Kansas Department of Agriculture Division of Water Resources

RE: Water Right, File No. 25312

DWR FIELD OFFICE APPLICATION FOR APPROVAL TO CHANGE THE PLACE OF USE AND/OR THE POINT OF DIVERSION

RE: Application for Change in Point of Diversion

Change in Point of Diversion for Water Right 25312

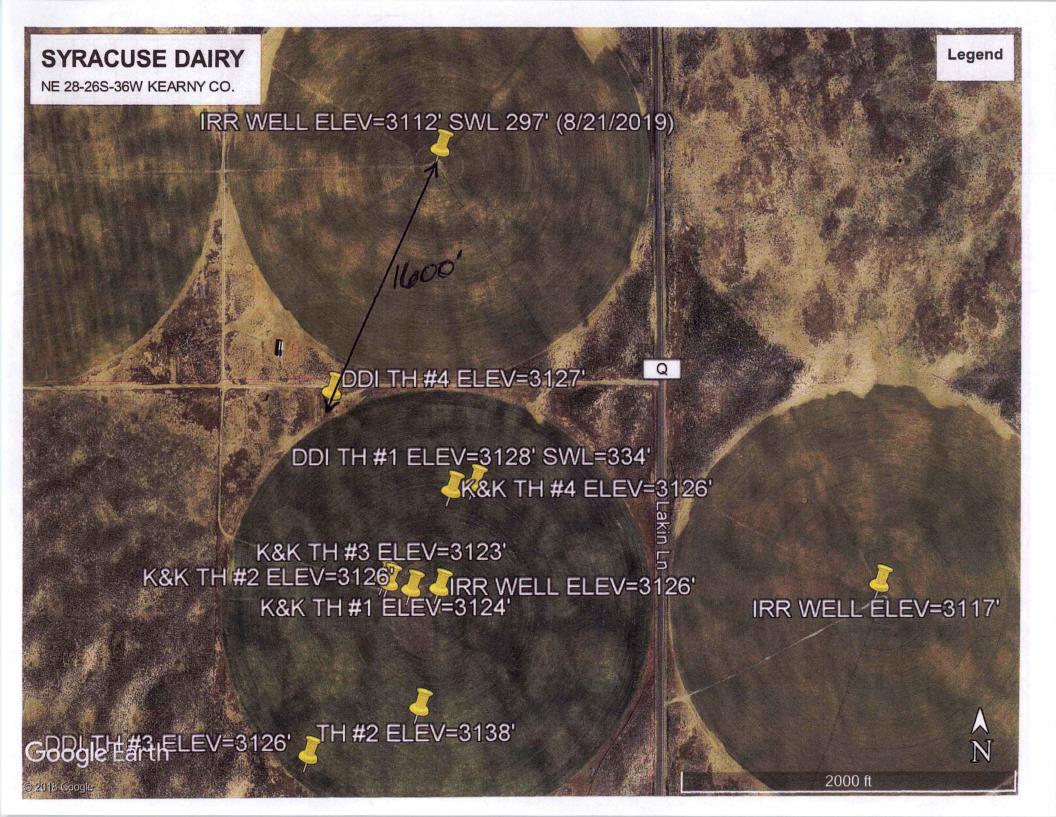
To the best of our knowledge, there are no other domestic wells in Sections 21 & 28 T26S R36W.

All wells within 1/2 miles are on this map.

Evaluation of proposed move for Water Right No 25312

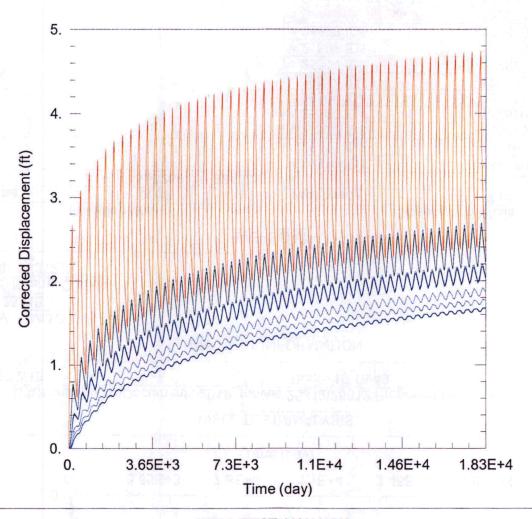
Drawdown from current location = 2.16 ft

Drawdown from proposed location = 3.16 ft

Net drawdown = 1.0 ft

Net drawdown does not exceed the drawdown allowance on any neighboring wells, so critical well analysis is not necessary.

Recommendation: Analysis of wells in the area allow for 4' effect, calculations showed no effects greater than 2.2', so well within tolerance. The application appears to meet the current area rules and should have minimal effect on neighboring wells. Staff therefore recommends approval of the application.
